Access Compliance Report

Public Rights-of-Way

Intersection ID: 31430	Main Street: BRAWER_FARM_DR	Cross Street: HEYSHAM_LN	Location: S
ADA ID: 49B9E2CBDA7E	Ramp Type: BlendTrans1	Initial Pass/Fail: Pass	Overall Compliance: No
Codes/Mitigation Info/Possible Solution		Field Measurements/Component Compliance	
Severity Score: 10

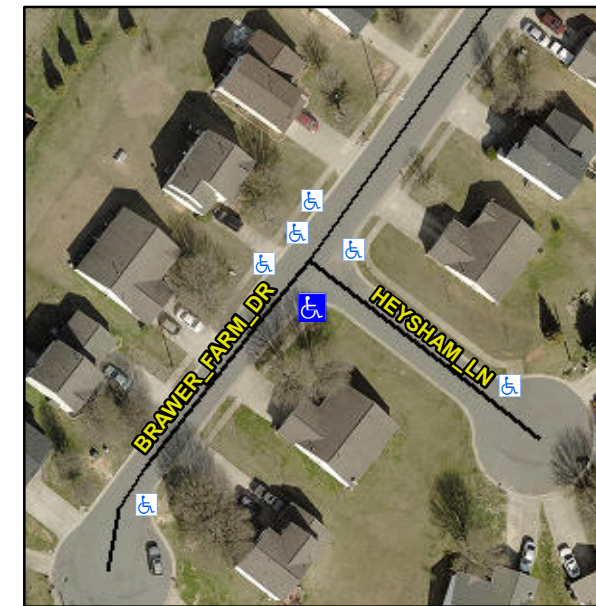
NO LT SW

Not Found, R304.2.2-Perp, R304.3.2-Para, R305, R304.5.3

Remove & Replace Curb Ramp With Two New Directional Ramps or Equivalent. Remove & Replace Gutter.
